NSLPP MEETING HELD ON 07/06/2023

ADDRESS/WARD: 131-139 Holt Avenue, Cremorne

APPLICATION No: DA239/2021/02

PROPOSAL: Section 4.56 modification relating to development consent DA239/2021 for excavation (not including demolition) and construction of a part four-part five storey mixed use development with basement parking, and stratum subdivision.

Figure 1. Proposed Site Plan

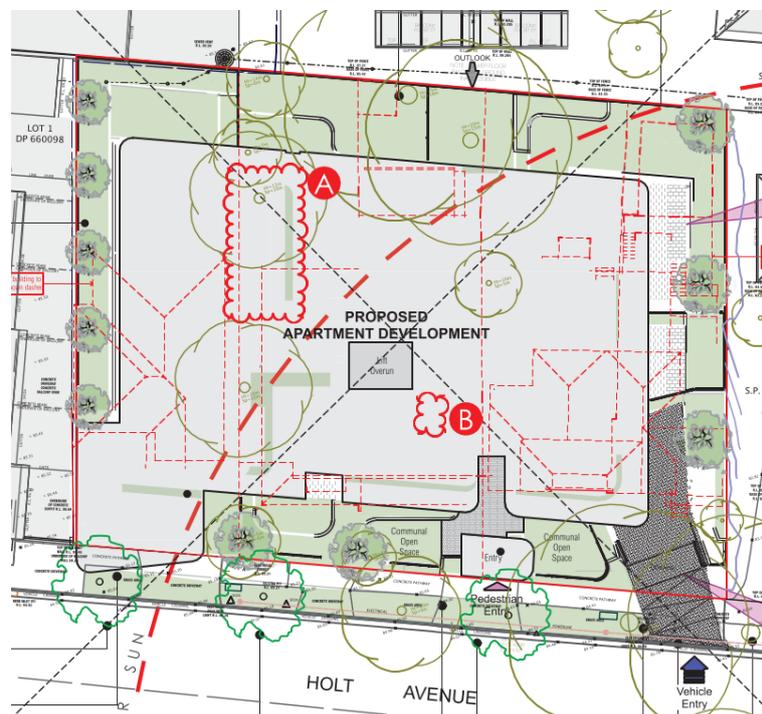
- Addition of an edge beam detail to break down the thickness of the roof edge surrounding the eastern edge the roofs over levels 3 and 4.
- Addition of a roof awning covering the approved balcony of apartment 401.

- Increases to the heights of the two lift overruns from RL97.400 to RL97.850 (+450mm) and RL100.600 to RL100.950 (+350mm), respectively, to allow for the use of a full height (2.7m) lift cabin.

Figure 5. Proposed Southeastern Elevation

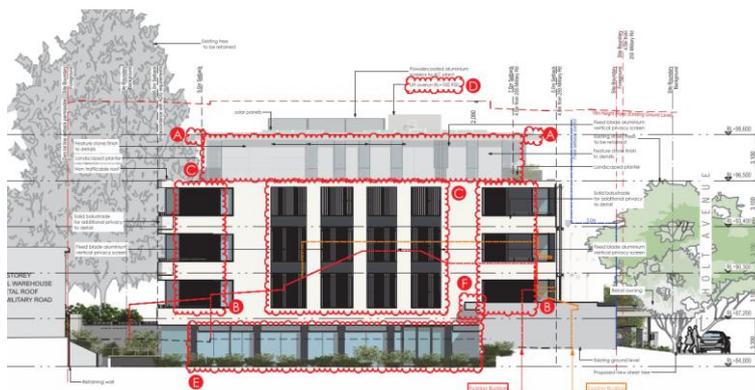
The proposed modifications resulting in new or varied variations to the height of building development standard in Clause 4.3 in NSLEP 2013 involve an increase to the lift overrun heights, an additional balcony roof awning, and roof details and have been considered having regard to the reason for approval of the original application and have been assessed having regard to the objectives of the development standard itself. The proposed modifications are consistent with the objectives given that the variations would not substantively alter the bulk and scale of the approved development and would not give rise to any additional material impacts on the amenity of the surrounding properties or the character of the area.
